May 14, 1981

Title: FRC TER: Override and Reset of  
Control Circuitry in the Ventilation/  
Purge Isolation and Other Engineered  
Safety Feature Systems - Duane Arnold  
Energy Center

### OVERRIDE AND RESET OF CONTROL CIRCUITRY IN THE VENTILATION/PURGE ISOLATION AND OTHER ENGINEERED SAFETY FEATURE SYSTEMS

IOWA ELECTRIC AND POWER COMPANY  
DUANE ARNOLD ENERGY CENTER

Figure 1. PCIS Control Scheme

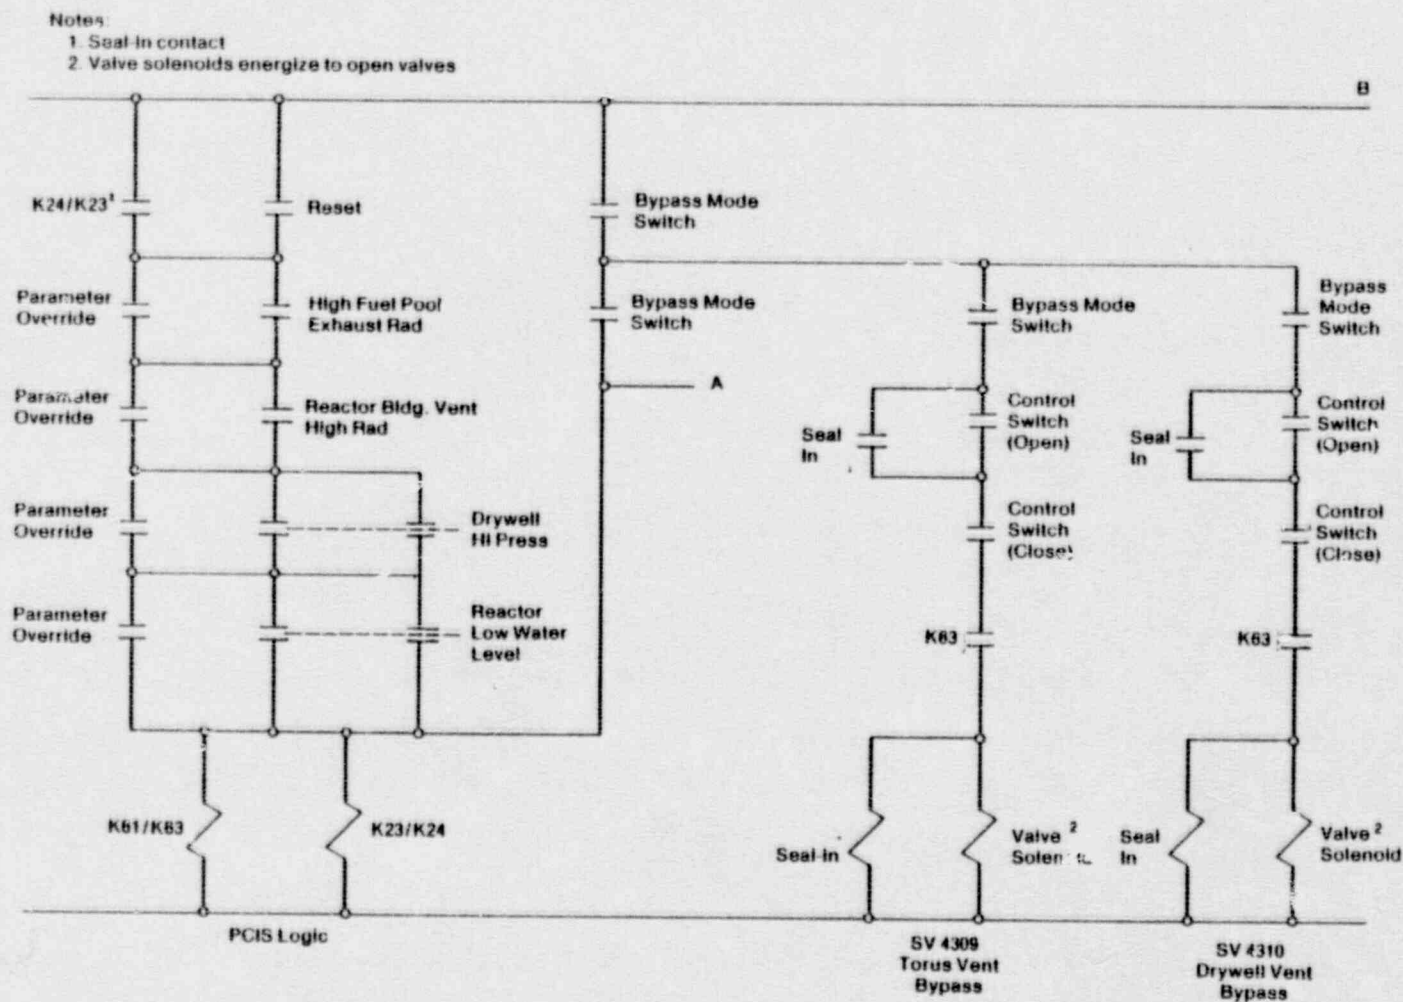
Trip relays associated with each isolation parameter operate contacts, arranged in series-parallel configuration (Figure 1), to provide power to two

No instances were found where the overriding of one type of safety actuation signal (e.g., drywell high pressure) causes the blocking of any other type of safety actuation signal (e.g., reactor low level) for those valves that have no function besides containment isolation. Therefore, it was concluded that NRC staff Criterion 1 has been satisfied in the PCIS at DAEC.

Override switches provided (GE Model CR2940 Form UN200D) are keylock-type switches and will support adequate administrative controls. Therefore, it was concluded that NRC staff Criterion 2 has been satisfied in the PCIS at DAEC.

Each override switch provides one contact which energizes an amber light in the control room to display the bypass condition to the operator for each individual trip parameter when the switch is placed in the override position. Also, the four override switches in each division of isolation logic are connected to a common annunciator window in the control room, such that any one of the four key switches placed in the override position results in an alarm which requires operator acknowledgment. Therefore, it was concluded that NRC staff Criterion 3 has been satisfied in the PCIS at DAEC.

The four isolation parameters listed in Section 2.2 will automatically initiate containment ventilation isolation. However, there is no radiation detector that monitors the primary containment atmosphere. The two radiation detectors which initiate PCIS monitor the fuel pool area and the reactor building. Therefore, Criterion 4 is not satisfied.

The overriding or resetting of any actuation signal will not cause any valve or damper to change position. This is accomplished by the use of seal-in relays and contacts at the equipment level and also by the provision of reset and override controls at the accident parameter level. Therefore, it was concluded that NRC staff Criterion 6 has been satisfied in the PCIS at DAEC.

It is concluded that the PCIS circuit design at AEC satisfies the NRC staff criteria for containment ventilation and purging operation with the exception of Criterion 4. Satisfaction of Criterion 4 will require that a radiation detector which monitors containment (i.e., drywell or torus) activity be provided and used to automatically initiate primary containment isolation.

Figure 2. Typical PCIS Valve Control Circuits

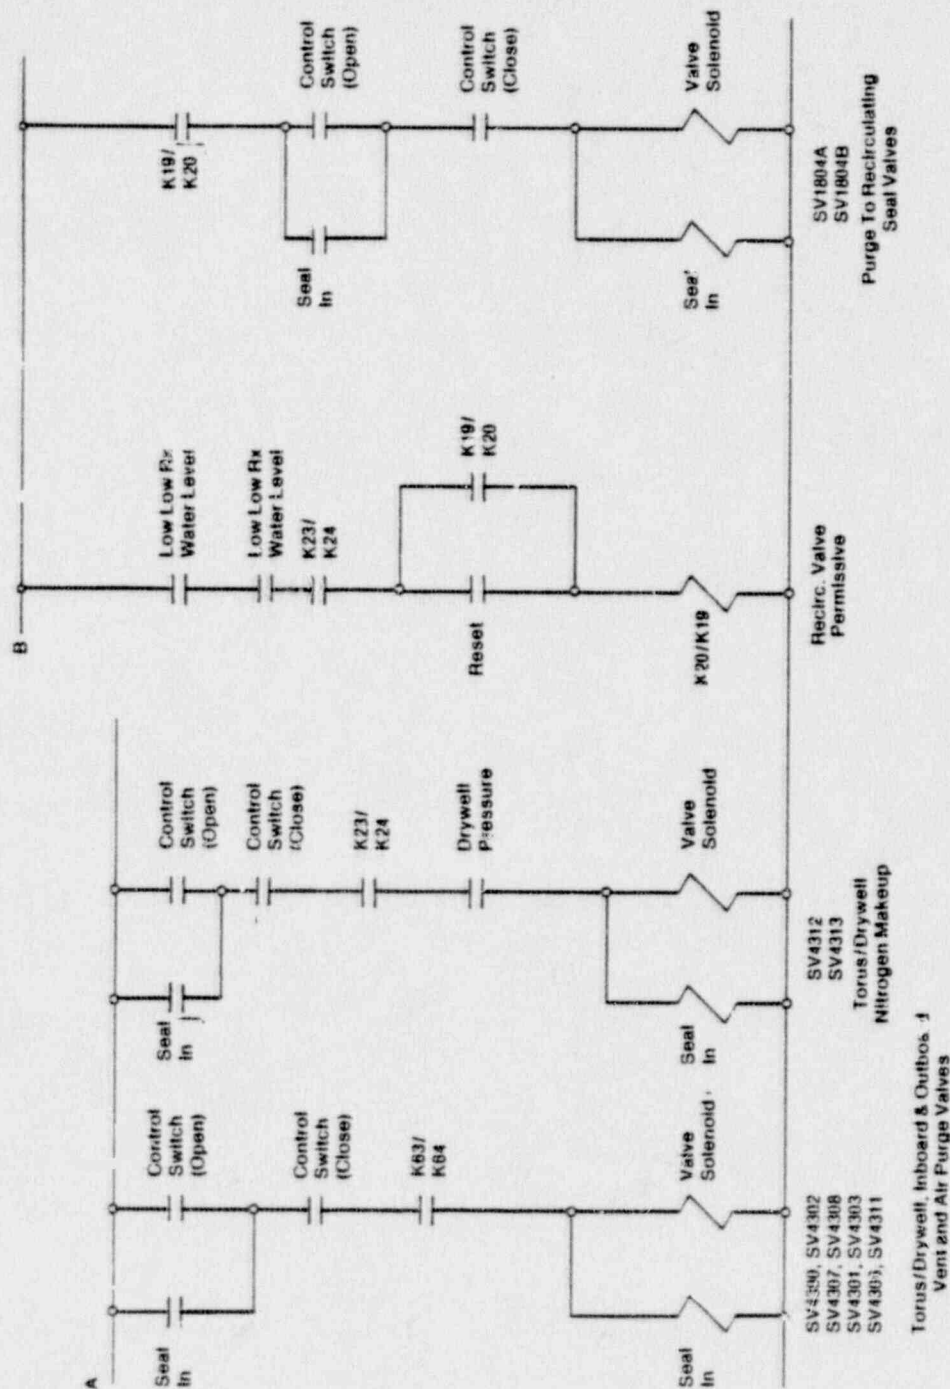
The torus and drywell, inboard and outboard, vent and purge valve control circuits (Figure 2) receive power from the output of the trip logic network (i.e., these control circuits are in parallel with the slave relays). Consequently, the pilot solenoids for these valves may be energized only when all trip signals are cleared or bypassed (the same condition required for slave relay energization). In addition, slave relay contacts are provided in series with each valve operator pilot solenoid.

The valve control circuits for the torus and drywell nitrogen makeup valves (Figure 2) are the same as those for the vent and purge valves with the addition of series contacts which open when the drywell pressure is greater than 1 psig. These contacts provide automatic control of nitrogen inerting the containment.

The valve control circuits for the purge to recirculating seal valves (Figure 2) receive power from upstream of the trip logic network. For these valves, the slave relay contacts operate in a valve permissive circuit in lieu of directly activating contacts in the valve control circuits. The valve permissive relay is in series with two sets of reactor low-low water level

Figure 3. RHR Control Logic

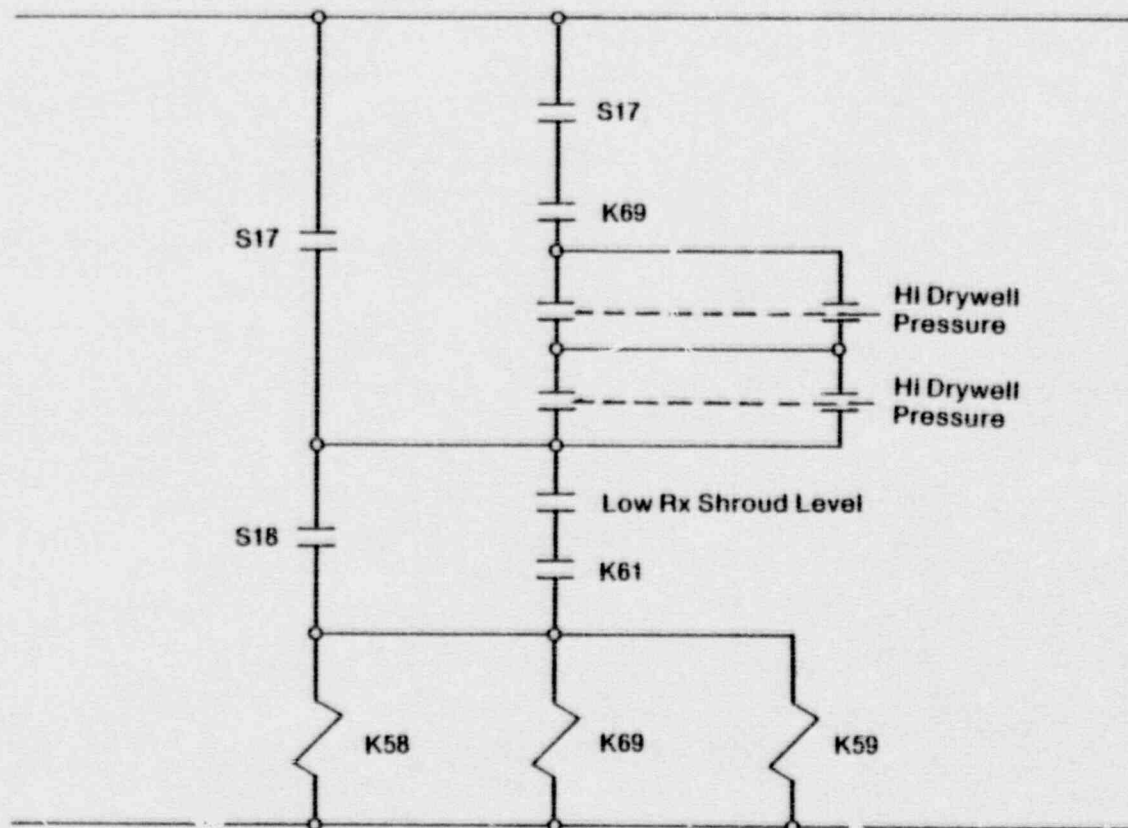
The contacts from the control functions are in an "or gate" configuration and the logic circuit is provided with a seal-in relay (K9) and contact as well as a reset control (Figure 3).

signal for those valves that have no function besides containment isolation. However, ten ESF actuated valves (MO-2000, MO-1902, MO-2005, MO-1932, MO-2007, MO-1934, MO-2006, MO-1933, MO-2001, and MO-1903), which have functions in addition to containment isolation, are provided with control circuitry that allows the bypassing of automatic ESF actuation (see Figures 4 and 5). These valves are normally shut on RHR automatic initiation. They may be opened through the use of two or three manual switches, a local keylocked control switch (42/CS, Figure 5), and either S17 or S17 and S18 (keylocked) depending on the presence of an automatic initiation signal and low reactor vessel shroud level (see Figure 4). Following these manual actions, the automatic initiation of RHR will not cause these valves to close. Although not a literal violation of Criterion 1, this situation has been identified for NRC staff evaluation with respect to acceptability.

Two of the three switches required to bypass the RHR valves identified above (S18 and local control switches) are keylock-type switches and will support adequate administrative controls. In addition, system level annunciation of this condition is provided. Consequently, Criteria 2 and 3 are satisfied for these ten valves. Criteria 2 and 3 do not apply to other RHR valves.

The overriding or resetting of any RHR actuation signal will not cause any valve or damper to change position. Therefore, it was concluded that NRC staff Criterion 6 has been satisfied in the RHR system at DAEC.

The RHR circuit design at DAEC satisfies the NRC staff criteria with the exception of Criterion 1 for ten valves which have functions in addition to containment isolation. These ten valves (listed in Section 2.4.2.1) may be required to provide containment spray for pressure control of the containment atmosphere in an accident environment. Opening of the valves in question requires multiple switch (keylock-type) operation, and system level annunciation is provided. In view of the possible operational requirements, administrative controls, and annunciation, FRC concludes that no modification to the RHR control circuit design is necessary.
